URGENT FIELD SAFETY NOTICE

Subject: CIAO incorrectly calculated in RT Chart

Commercial Name of Affected Product: RT Chart, a function of ARIA™

FSCA Identifier: CP-03103

Details:

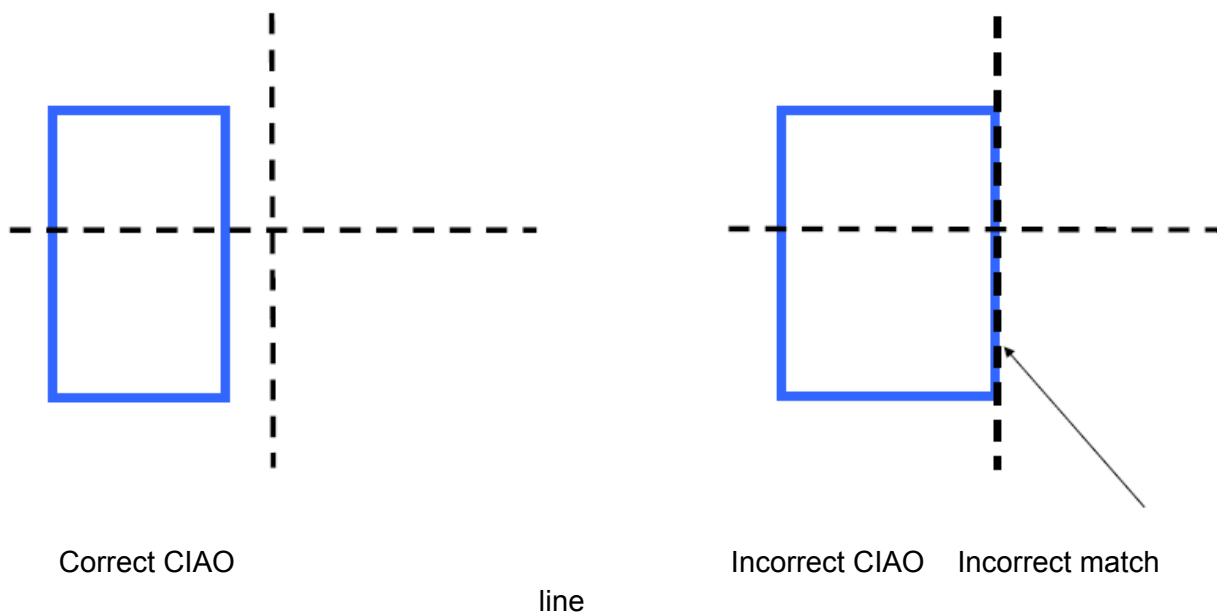
When an image sequence template is added to a field in RT Chart and a CIAO is calculated, the resulting CIAO display at 4DITC may be incorrect. This CIAO calculation interprets the following data incorrectly:

- a) Closed leaf motions ($\leq 0.5\text{mm}$) are incorrectly considered as part of the field
- b) Leaves travelling over isocenter are truncated to the central axis

The result is a CIAO which is in many cases larger than the actual largest extent of irradiated area – possibly leading to an unintentional gap if that outline is used for edge matching of a second field.

When a portal image sequence image is scheduled for a session in RT Chart, the daemon will create an image beam for the 4DITC during the plan load. This image beam contains the associated field aperture and the MLC leaf positions.

Due to the misinterpretation of the closed leaf motions and leaves travelling over isocenter, the display of the CIAO may differ when visualized in RT Chart, Eclipse, 4DITC, and offline review.

1. Varian recommends a QA practice that includes routine patient setup and planned isocenter/treatment volume verification prior to treatment delivery regardless of documented patient plan setup instructions. This verification can be done through the use of MV imaging or use of film prior to patient treatment.
2. In the case where an erroneous CIAO exists and a correct image is required for use for edge matching, view the CIAO in offline review prior to treatment

1. Varian is notifying potentially affected users by way of this Urgent Field Safety Notice.
2. Varian has made design changes to address this issue in ARIA Radiation versions 8.2 and later. A corrective action will be undertaken to upgrade all affected systems to an unaffected later version of the software. If this has not already been done on your system, you will be contacted to schedule the update on your system.
